June 17, 2008

**TO:** Columbia River Crossing Task Force  
**FROM:** CRC Pedestrian and Bicycle Advisory Committee (PBAC)  
**SUBJECT:** PBAC Recommendations for World Class Pedestrian and Bicycle Facilities

**Purpose of this Memorandum**

PBAC Proposed Pedestrian and Bicycle System for Replacement Bridge

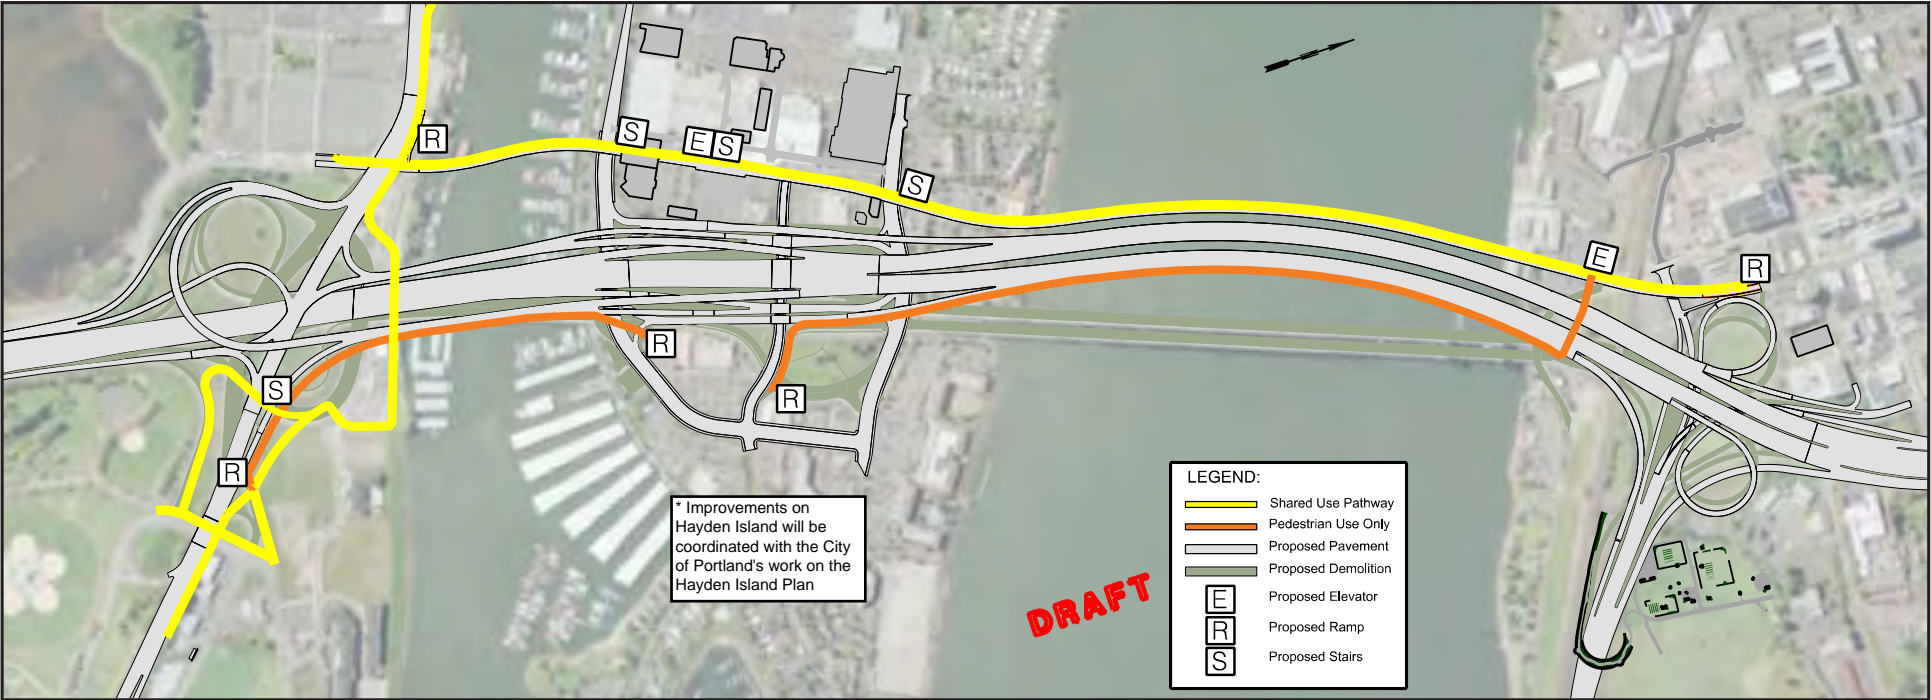
- The overall pathway on the western bridge (adjacent to the transit guideway) must provide separation between recreational users and higher speed bicycle users. To provide this separation, a 12-foot wide regional trail should be provided adjacent to, and to the west of, a pair of six-foot wide bicycle lanes (see attached rendering). These recommended widths are exclusive of potentially needed shy distances, i.e., free and clear of poles and other obstructions to enable safe pedestrian and bicycle movement (a summary of agency standards for multiuse paths, sidewalks and bike lanes is attached).

The regional trail would accommodate pedestrians, persons with disabilities, seniors, families with children, tourists, roller-skaters, and recreational bicycle riders. The adjacent bicycle lanes would be used by bicycle commuters and other faster-moving bicyclists. The regional trail would be at a slightly higher level than the bicycle lanes, but bicyclists in the bicycle lanes would be able to access the trail. Different paving treatments and/or patterns should differentiate the regional trail and the bicycle lanes.

- In addition to the combined regional trail and bicycle lanes on the western bridge, an eight-foot wide sidewalk should be provided on the eastern bridge (the bridge that would serve the northbound traffic lanes) across both the Columbia River and the North Portland Harbor. The sidewalk across the North Portland Harbor would touch down on Hayden Island and use surface street sidewalks to connect to the sidewalk across the Columbia River.
